Economic Commission for Europe**Inland Transport Committee****World Forum for Harmonization of Vehicle Regulations****182nd session**

1958 Agreement:**Consideration of draft amendments to existing****UN Regulations submitted by GRSP****Proposal for the 02 series of amendments to UN Regulation
No. 137 (Frontal impact with focus on restraint systems)****Submitted by the Working Party on Passive Safety ^{*},^{**}**

Figure 3

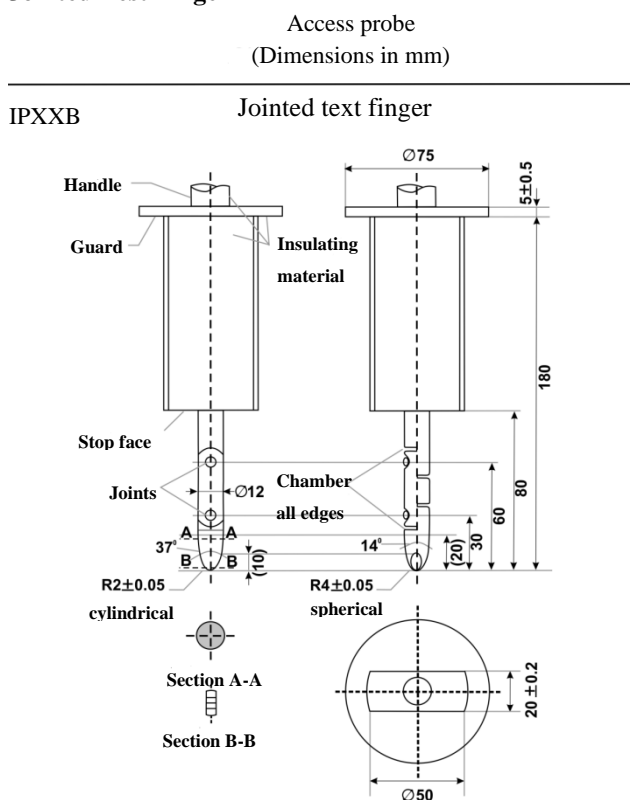
Paragraph 4., amend to read:

The jointed test finger described in Figure 3 shall be inserted into any gaps or openings of the physical protection with a test force of $10 \text{ N} \pm 10$ per cent for electrical safety assessment. If partial or full penetration into the physical

Starting from the straight position, both joints of the test finger shall be rotated progressively through an angle of up to 90 degrees with respect to the axis of the adjoining section of the finger and shall be placed in every possible position.

Both joints shall permit movement in the same plane and the same direction through an angle of 90° with a 0 to +10° tolerance.

The requirements of paragraph 5.2.8.1.3. of this Regulation are met if the jointed test finger described in Figure 3, is unable to contact high voltage live parts.

Figure 4
Example of the Test Method using DC Power Supply

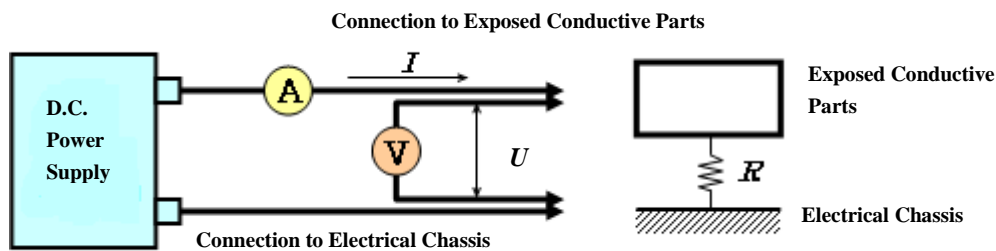
(b) Test method using DC power supply, voltmeter and ammeter.

Example of the test method using DC power supply, voltmeter and ammeter is shown below.

The voltage of the DC power supply is adjusted so that the current flow becomes at least 0.2 A.

The resistance "R" is calculated according to the following formula:

The resistance R shall be less than 0.1 Ω.

Figure 5
Measurement of U_1'

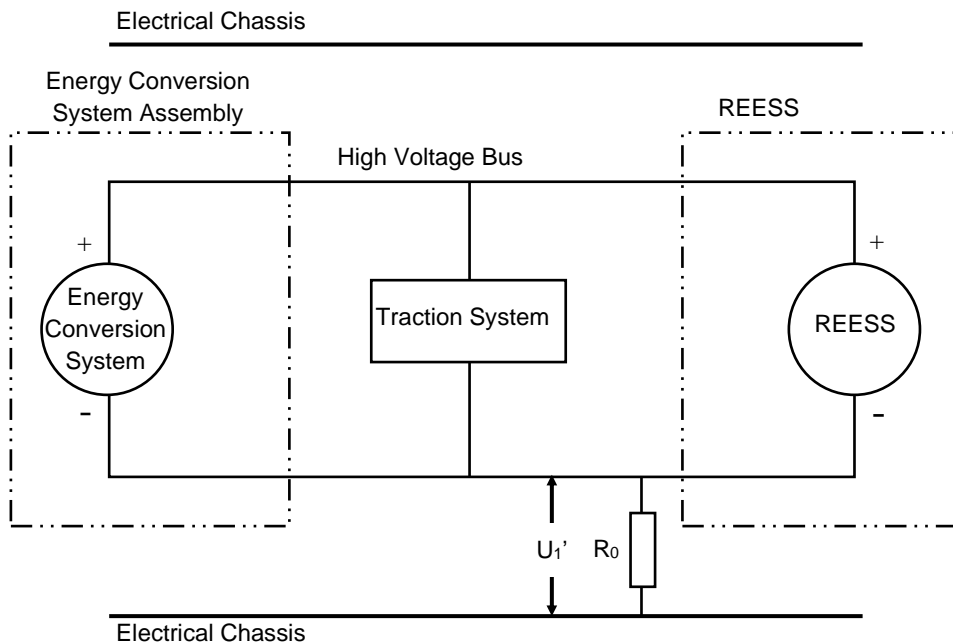
If U_1 is greater than or equal to U_2 , a standard known resistance (R_o) is inserted between the negative side of the high voltage bus and the electrical chassis. With R_o installed, the voltage (U_1') between the negative side of the high voltage bus and the electrical chassis is measured (see Figure 5).

$$R_i = R_o * U_b * (1/U_1' - 1/U_1)$$

Figure 6
Measurement of U_2'

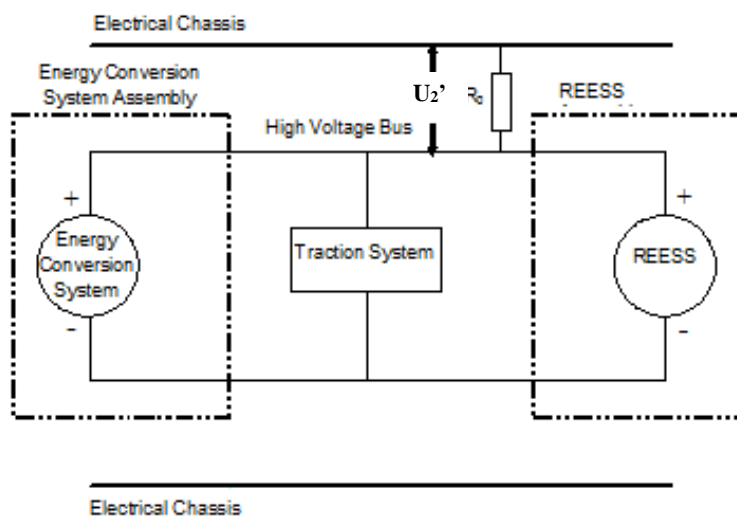
If U_2 is greater than U_1 , insert a standard known resistance (R_o) between the positive side of the high voltage bus and the electrical chassis. With R_o installed, measure the voltage (U_2') between the positive side of the high voltage bus and the electrical chassis (see Figure 6 below). The electrical isolation (R_i) is calculated according to the following formula:

$$R_i = R_o * U_b * (1/U_2' - 1/U_2)$$
